Re: CPV Sentinel Energy Project: Docket No. 07-AFC-3

Responses to Groundwater Workshop Data Requests

Application for Certification (07-AFC-3) for CPV Sentinel Energy Project Riverside County, California

Figure: 1

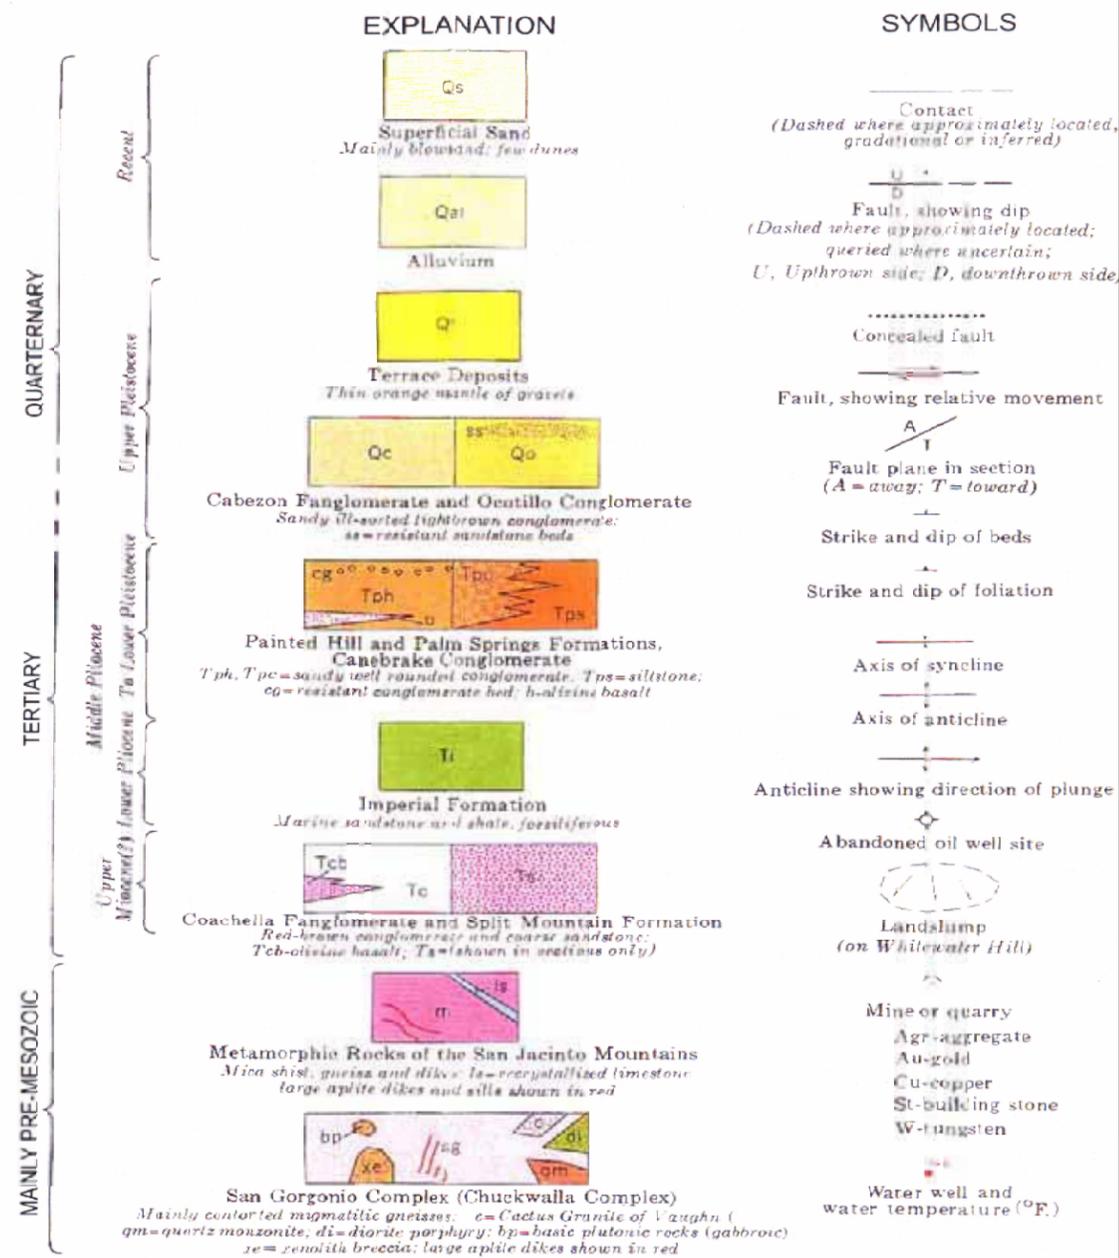
3. ***Model tests using ½ of the Tyley transmissivity distribution are not considered extreme (i.e., decreasing transmissivity by a factor of 2 does not encompass the potential uncertainty in transmissivity indicated by previous investigations). In regards to the data used to develop his distribution, Tyley stated “many of the transmissivity estimates based on these logs represent only an order-of-magnitude figure.” Although Tyley cites more than 400 driller’s logs were used to calculate transmissivity, he does not report how many of those logs were used to develop the distribution in the Mission Springs subbasin (one of 4 subbasins considered in the study). Tyley maps a range in transmissivity of about 270 to 27,000 ft²/day; the PSOMAS model reports a transmissivity range of about 1,300 to 61,000 ft²/day; and, the model calibration reported by Mayer et al. (2007) report a transmissivity range of about 170 to 2,700 ft²/day. Decreasing transmissivity by at least a factor of 10 seems more representative of the uncertainty in transmissivity reported by Tyley and indicated by more recent modeling investigations.***

URS took all available well data and summarized it on Table 1 (attached). These known well locations are shown on Figure 1 (attached). Figure 2 includes Tyley's T distribution and Figure 3 plots more recent T data and distributions (i.e., after 1970). Comparing Tyley's T distribution to the T distribution using more recent data clearly indicates that Tyley's T distribution errs on the conservative low side. Accordingly, for reasons outlined in the response to Data Request 2 and by data available since 1970, the use of the Tyley T distribution and values in the CPV model is considered a reasonable and conservative approximation of T values within the Mission Creek Subbasin.

Figure 1: Generalized Groundwater Flow Lines and Section along Banning Fault Where Main Subsurface Outflow Occurs for 1967 (Source: Tyley 1974, Figure 16)

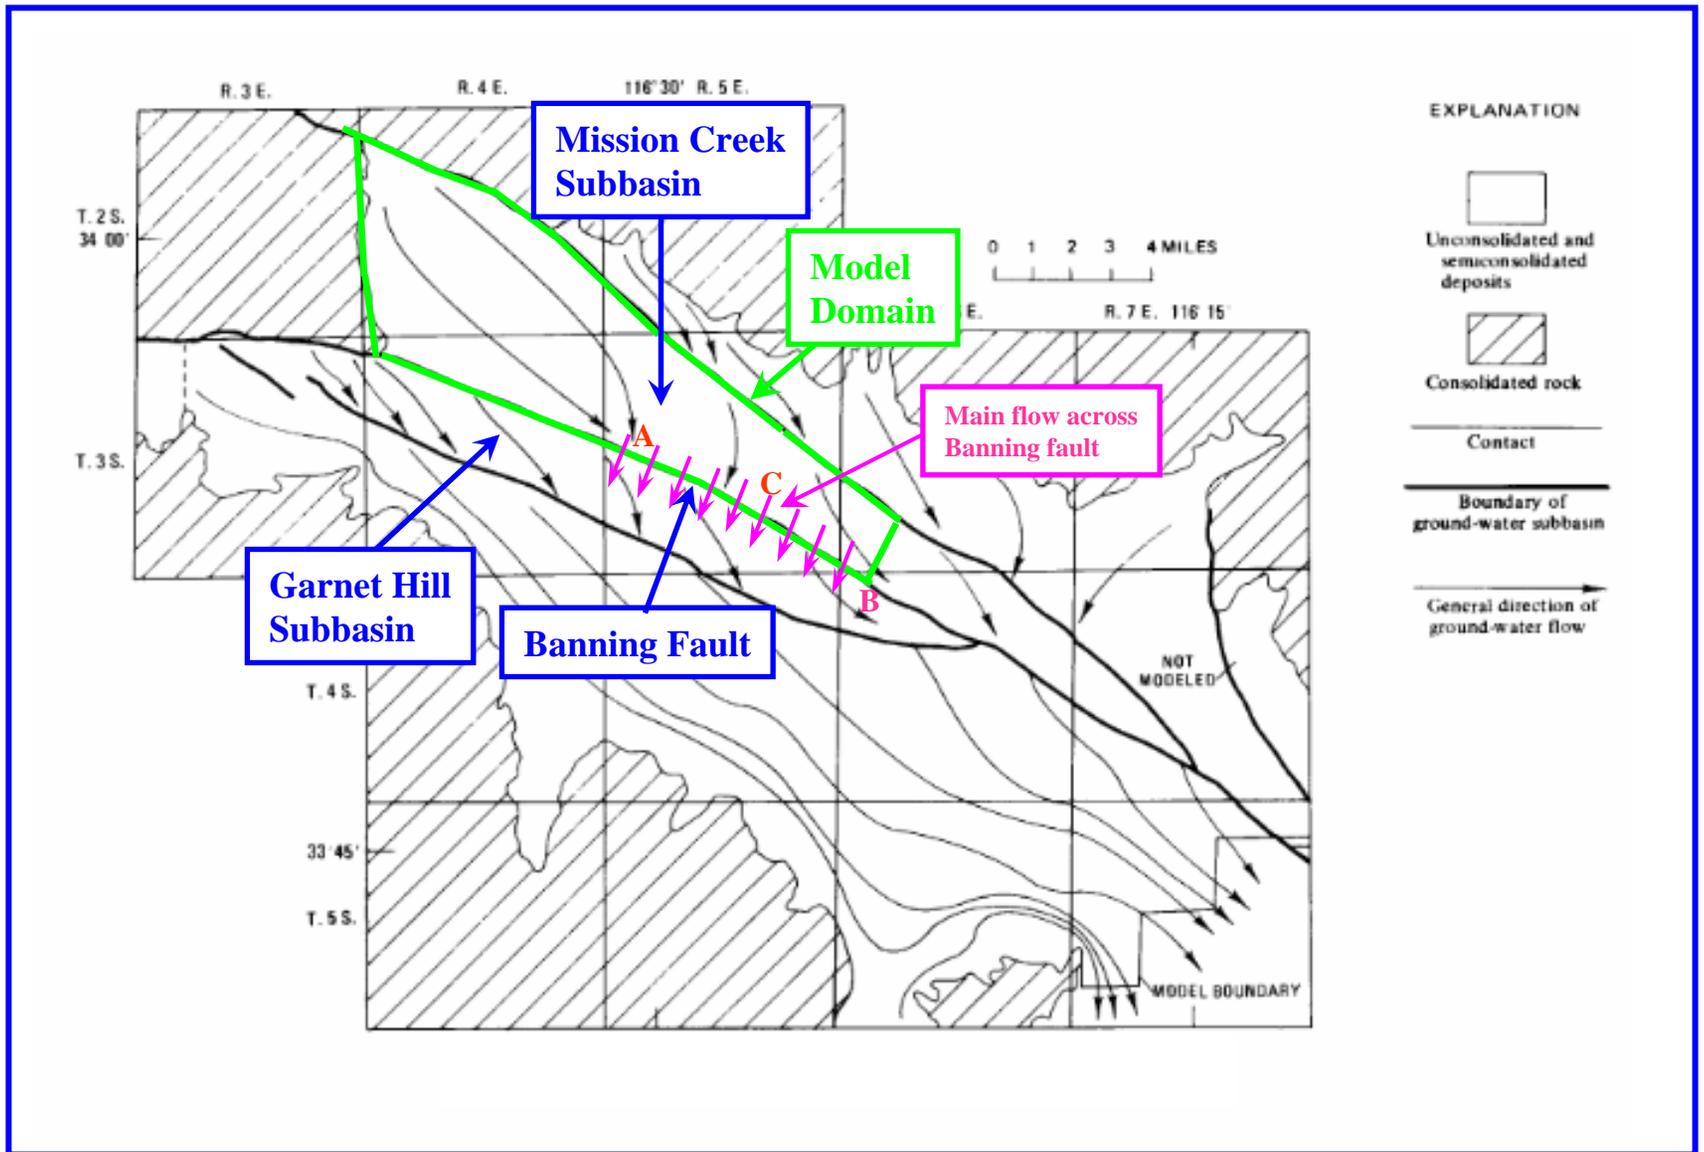
6. ***In the CPV model, the simulated head changes that change the net hydraulic gradient across the Banning Fault are probably small, and its possible net flow across the fault can indeed be ignored. However, the model calibration reported by Mayer et al. (2007) indicated outflow from the Masson Creek subbasin across the Banning Fault is significant and represented 33% of the total 1998 subbasin outflow. It therefore seems the possible effects of the fault on net water level and groundwater storage changes simulated by this superposition model should be explored and documented.***

The subsurface outflow from Mission Creek Subbasin to Garnet Hill Subbasin through the Banning Fault mainly occurs along the southeasterly trending portion of the Banning Fault (see Figure 1), where a pronounced head difference exists (see Figures 2 and 3). Tyley (1974) estimated subsurface outflow across Banning fault is 2,000 afy, Mayer and May (1998) estimated subsurface outflow across Banning fault at 5,470 afy, and Mayer et al. (2007) estimated subsurface outflow of 1,530 to 6,900 afy across Banning fault.
